DESIGN REVIEW BOARD

Staff Report

File Number: 11-E-26-IH

Location: 1024 Crozier Ave. **Parcel ID:** 81 H C 010
Zoning: RN-2 (Single-Family Residential Neighborhood), HP (Hillside Protection Overlay)
Description: New primary structure

SITE PLAN

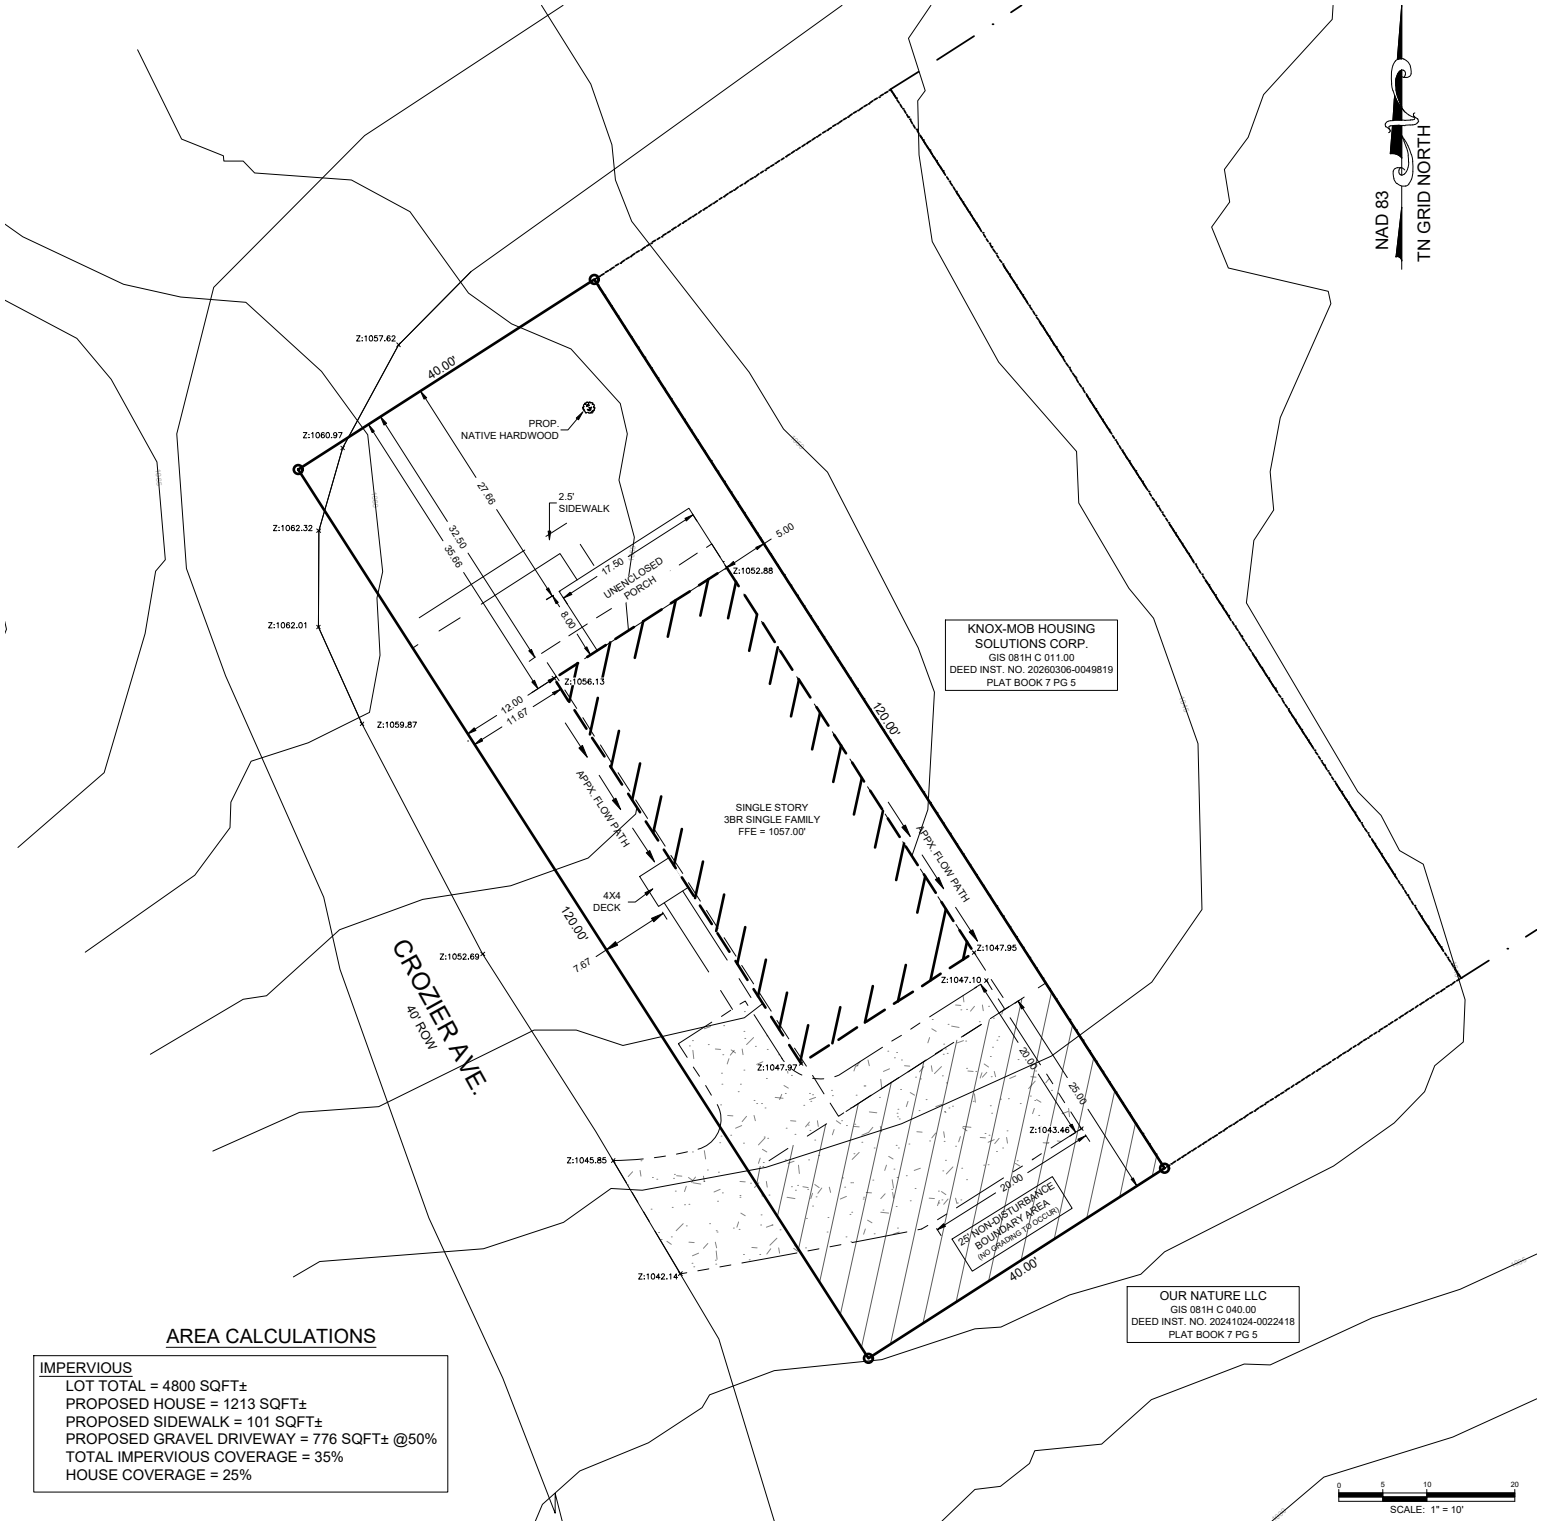
House Orientation and Side Yards: Appropriate. The site plan includes an 11.67’ corner side setback from Johnston Street, which does not meet the 12’ minimum required by the RN-2 (Single-Family Residential Neighborhood) district. The DRB can approve alternative dimensional standards “in order to realize the principles associated with the guidelines” (Article 16.6.D). The minor reduction to the corner side setback is consistent with others in the area and is appropriate for the 40’ wide lot. It does not pose safety concerns to City Engineering.

Landscape: Appropriate. The tree in the front yard should be an existing tree, as feasible. The non-disturbance boundary encroaches into the parking footprint. It should be revised to the area behind and east of the driveway.

Staff recommends approval of Certificate 11-E-26-IH, subject to the following conditions:
1) the final site plan to meet City Engineering standards;
2) allowing for the 11.67' corner side setback because it is consistent with surrounding development;
3) revising the non-disturbance boundary to the area behind and east of the parking pad;
4) major changes to the foundation height to return to the Board for review, and the brick veneer cladding to be retained;
5) retaining details as depicted, including but not limited to the porch header beam, minimum 6" by 6" turned porch columns, handrailing design, single-hung or double-hung window operation, trim at the base of gable fields, accent siding, and different siding colors from adjacent new construction.

FRONT PROFILE

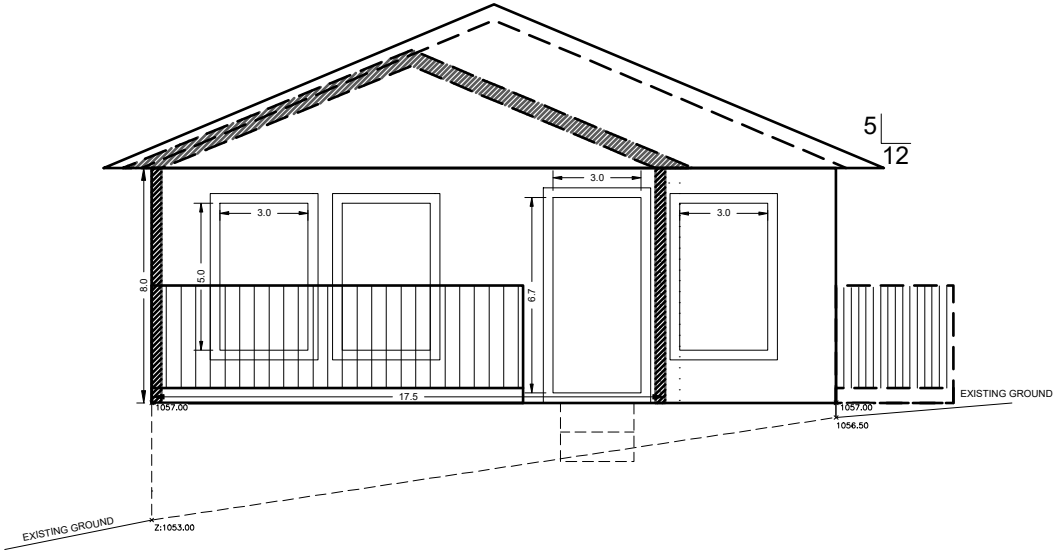
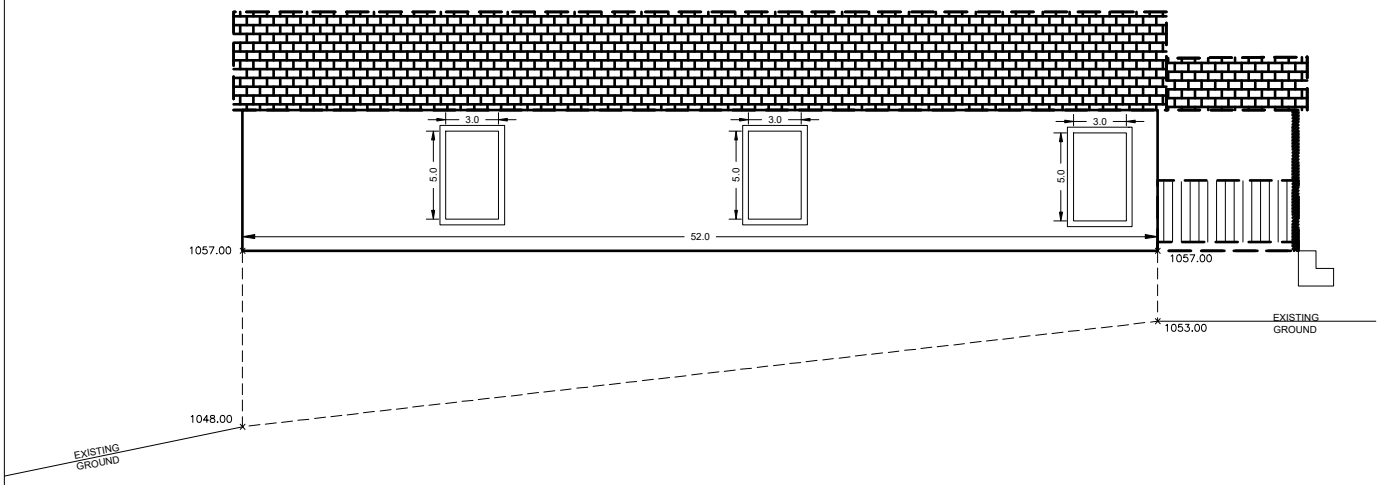
Front Yards: Appropriate. The setback is slightly deeper than the block, which features front setbacks ranging from approximately 20’-34’. However, the large front setback is necessary to provide safety and avoid the steep slope from the road at the property’s northwest corner.

Scale, Mass, and Foundation Height: The house is approximately double the depth of the two existing Minimal Traditionals on the blockface, but it is similar to the 48’ deep (porch not included) house that was approved earlier this year for 910 Crozier Avenue. The proposed foundation height is appropriate given the slope of the lot and other houses on the block, and major changes will require further review by the Board. The brick veneer cladding should be retained.
